Model: NAD 30S/30/40 1000 Finisher		Date: 07-Apr-00	No.: MA681001
Modified Article: Transport Roller and Lower Entrance Guide		Prepared by: E. Fukuyama	
From: Technical Services Dept., GTS Division			
Reason for Modification:	<input checked="" type="checkbox"/> Parts catalog correction	<input type="checkbox"/> Vendor change	<input type="checkbox"/> To meet standards ()
	<input type="checkbox"/> To facilitate assembly	<input type="checkbox"/> To improve reliability	
	<input type="checkbox"/> Part standardization	<input type="checkbox"/> Other

Model: NAD 30S/30/40 1000 Finisher		Date: 04-Jun-01	No.: MA681002
Modified Article: Junction Gate		Prepared by: E. Fukuyama	
From: Technical Services Dept., GTS Division			
Reason for Modification:	<input type="checkbox"/> Parts catalog correction <input type="checkbox"/> To facilitate assembly <input type="checkbox"/> Part standardization	<input type="checkbox"/> Vendor change <input checked="" type="checkbox"/> To improve reliability <input type="checkbox"/> Other	<input type="checkbox"/> To meet standards ()

Model: NAD 30S/30/40 1000 Finisher		Date: 07-Dec-01	No.: MA681003
Modified Article: Slider - Shift Tray		Prepared by: E. Fukuyama	
Fr

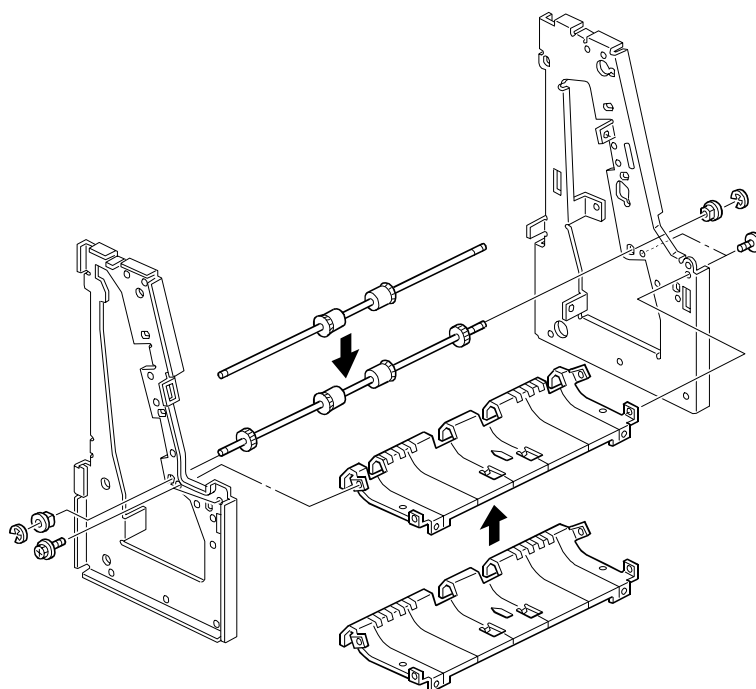
The following should be corrected.

The transport roller (**A6812331**) has 4 rollers attached to the shaft and the Lower Entrance Guide (**A6812221**) has 4 cut-outs for the rollers. This is a result of parts modifications applied to machines from the first mass production lot.

Old part number	New part number	Description	Q'ty	Int	Page	Index	Note
A6812331		Transport Roller	1	-	15	27	
A6812221		Lower Entrance Guide	1	-	15	29

Slider – Shift Tray

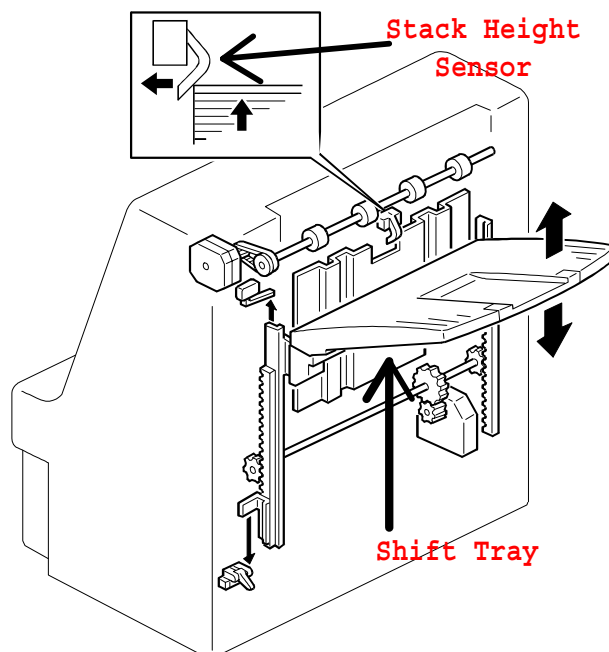
If the length of the Slider for the Shift Tray is near the specification maximum, it sometimes prevents the tray from activating the Stack Height Sensor. To ensure that the sensor is properly activated, the margin of error for the Slider length has been minimized from 76.5 \pm 0.30mm \rightarrow \pm 0.15mm.

Old part number	New part number	Description	Q'ty	Int	Page	Index
A6662251	A6813426	Slider – Shift Tray	1-1	X/O	11	8
